**BULLETIN**

NUMBER 176

**SUBJECT:** Elevator Control Tube Bellcrank Attachment

**MODELS AFFECTED:** PA-23 and PA-23 "160"  
Serial Numbers 23-1 to 23-1691 inclusive

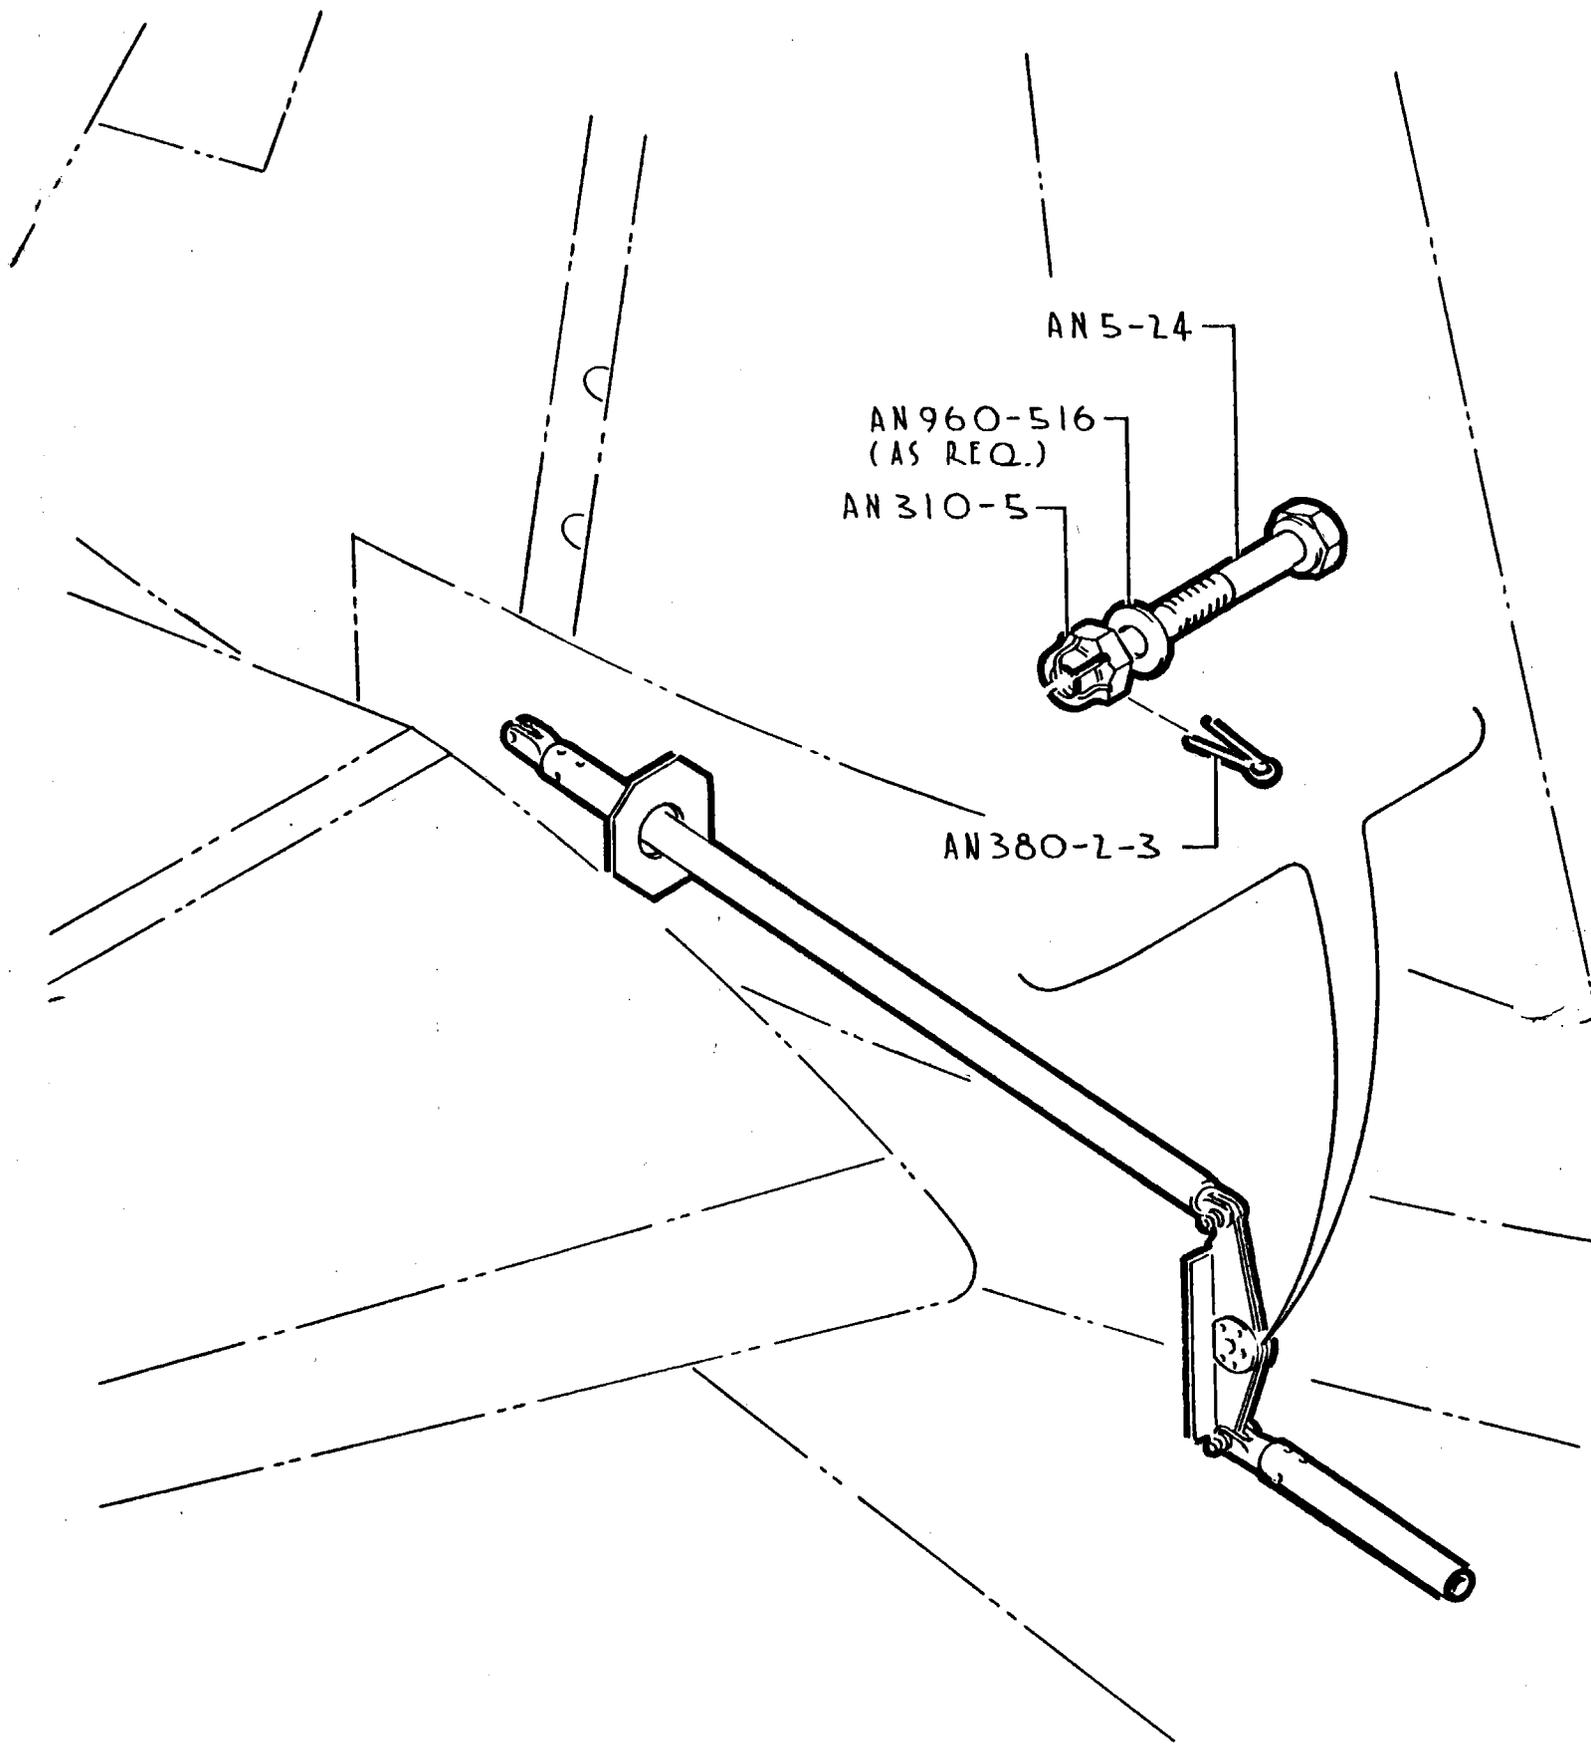
A report has been filed with the Service Department that the self-locking nut on the elevator control tube bellcrank attachment bolt has become loose. To preclude the possibility of an occurrence of this nature, a castellated nut and cotter pin is now being installed at this point in current airplanes.

It is requested that a bolt (AN5-24), nut (AN310-5), cotter pin (AN380-2-3) and washer (AN960-516) be installed at the next 100 hour inspection per sketch shown on the reverse side of this bulletin.
